TO: Town of Parker Recreation Department, Brett Collins
FROM: Carolyn Parkinson, Planner I
DATE: November 15, 2022
SUBJECT: SP22-099; Ray J. Harvie L1 Open Space
Review Comments 02

HARVIE OPEN SPACE PARK
SITE PLAN SUBMITTAL

SHEET TITLE:
MATERIALS & LAYOUT PLAN

L2.1

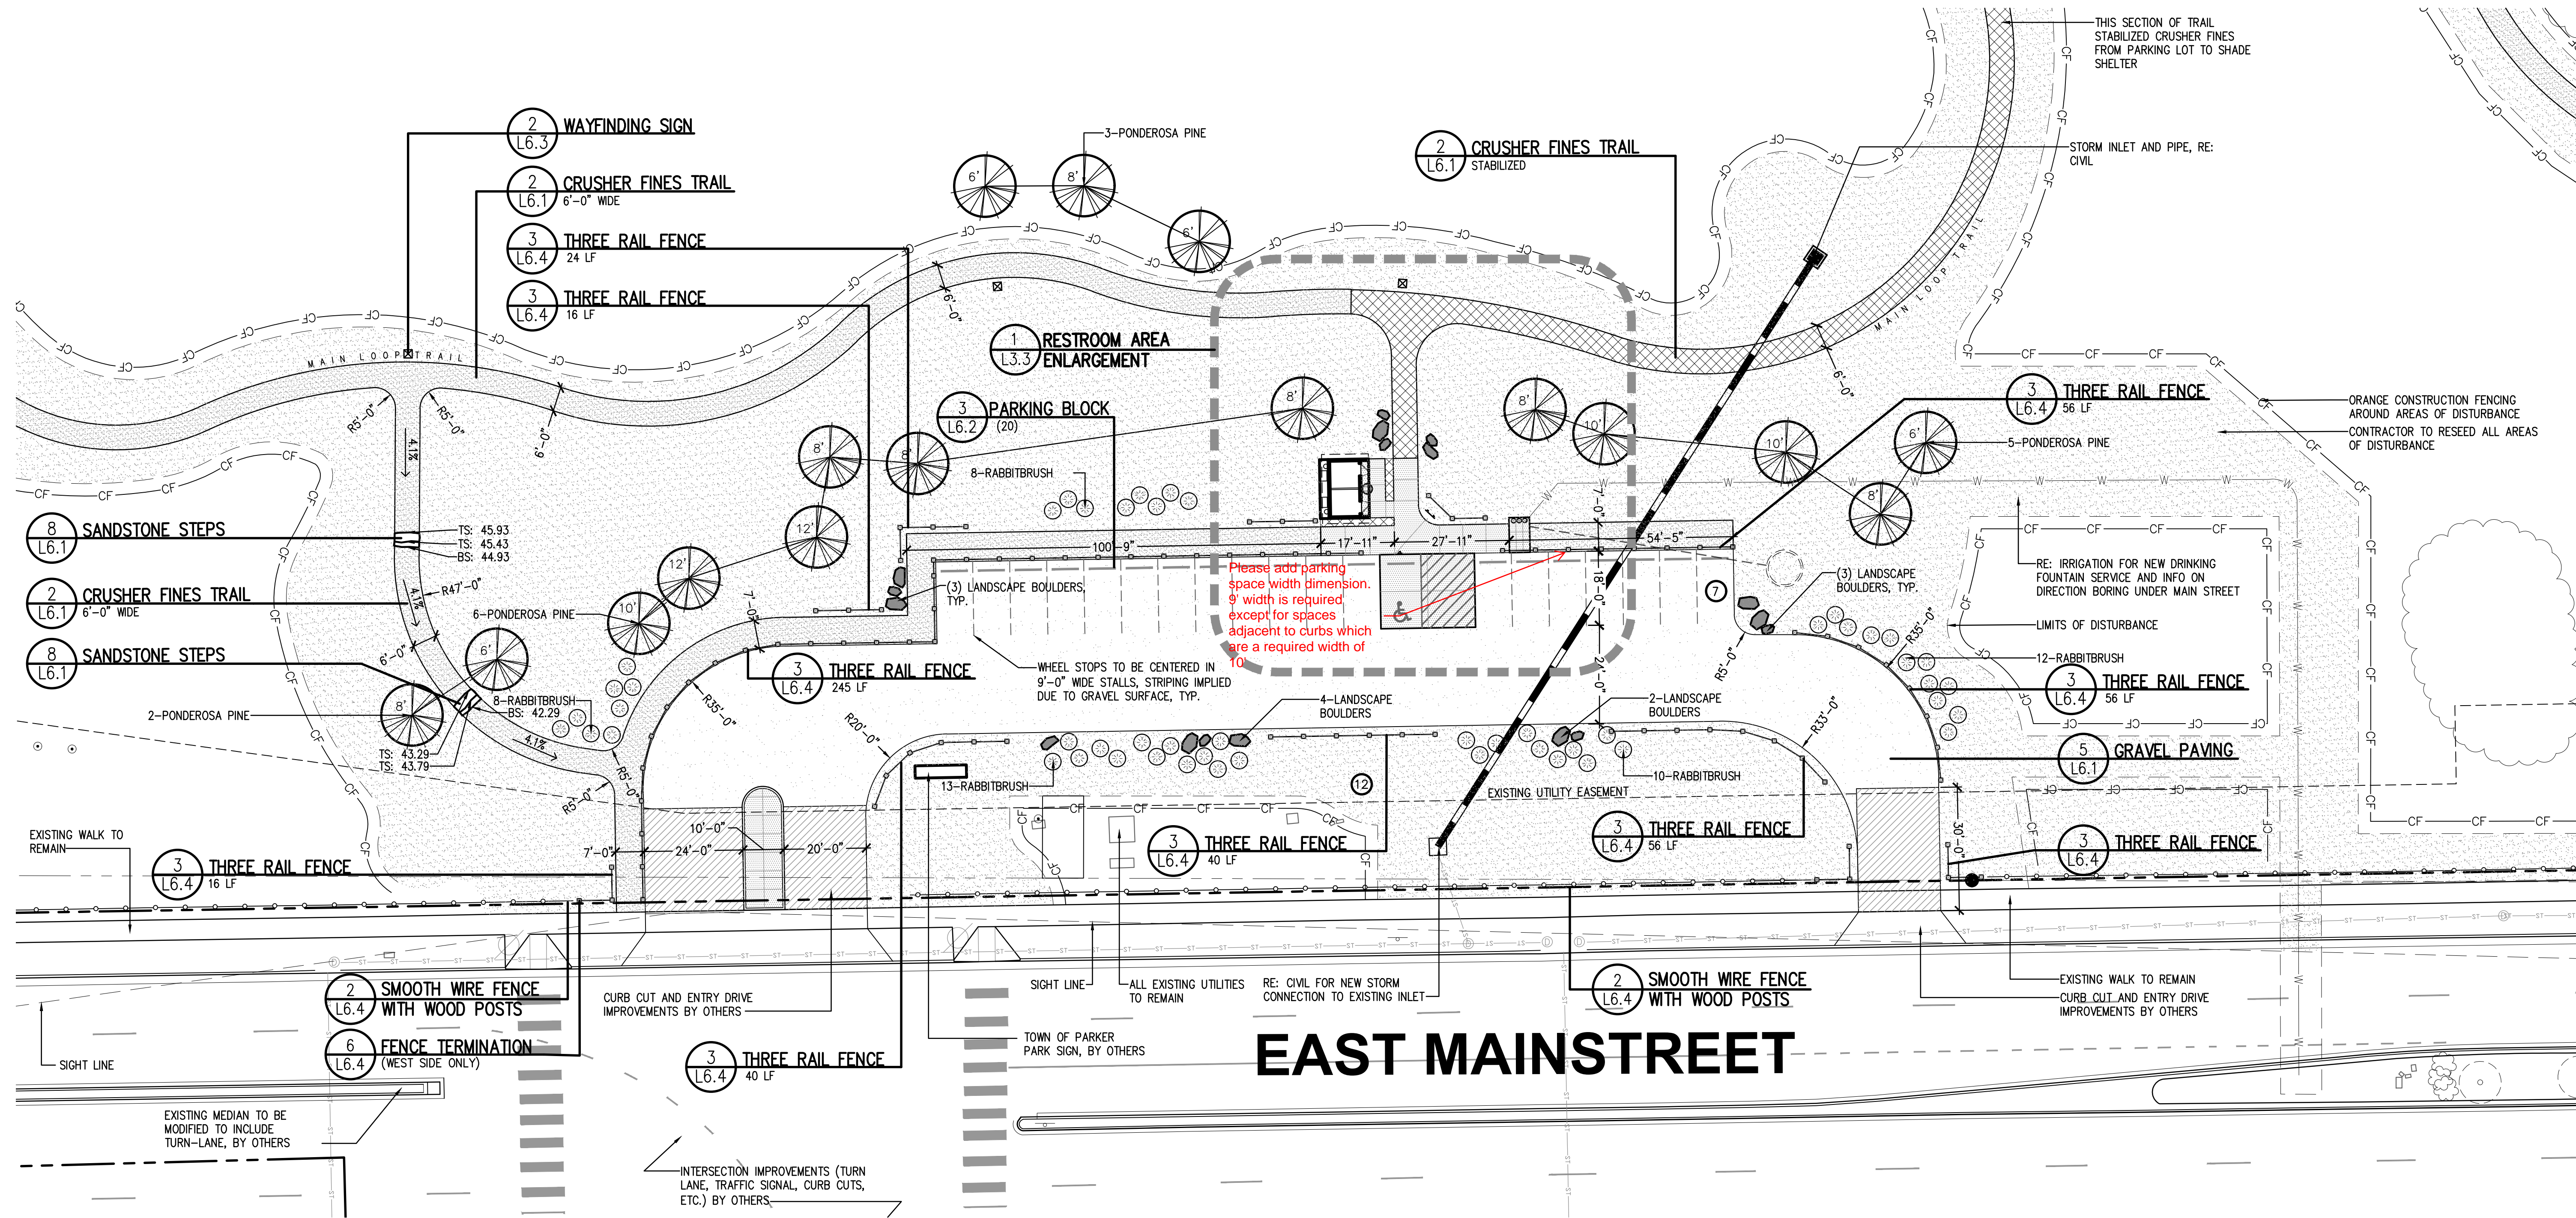
Please add waste stations for users with dogs. One near the main entrance and at least one additional near the shelter on sheet L2.7.

If possible, please add additional landscaping in the area between parking and roadway to help screen the parking lot.

4 COBBLE PAVING NOT TO SCALE

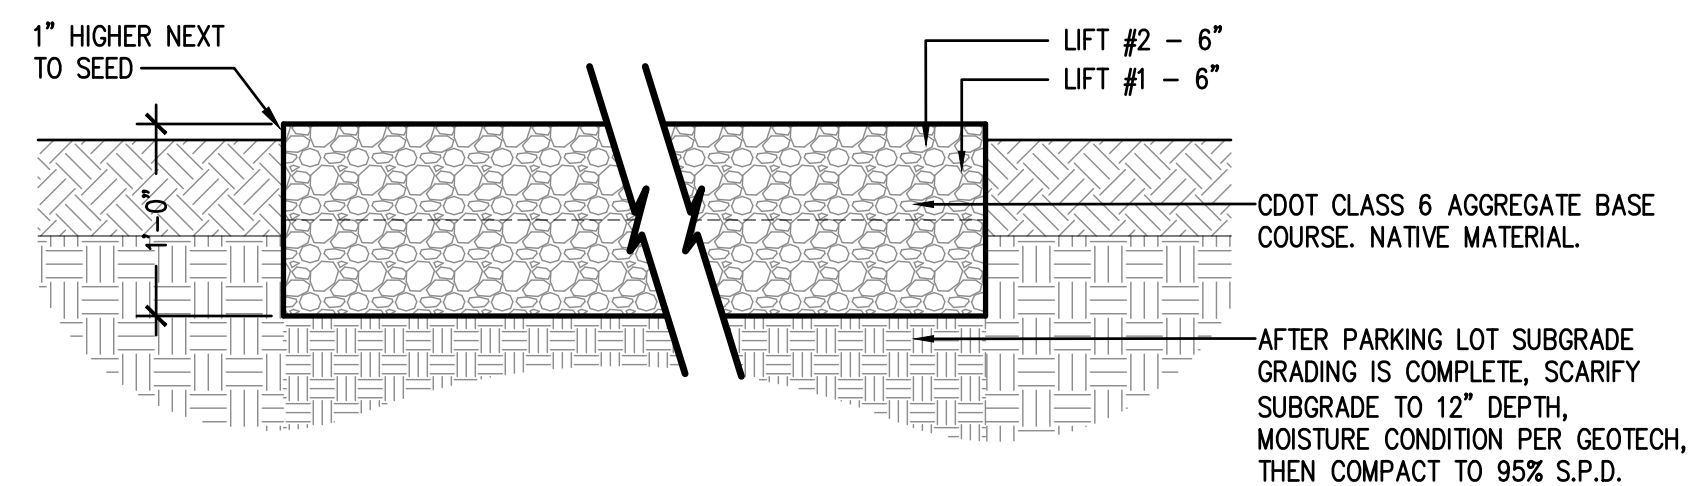
Staff cannot locate "Cobble Paving".
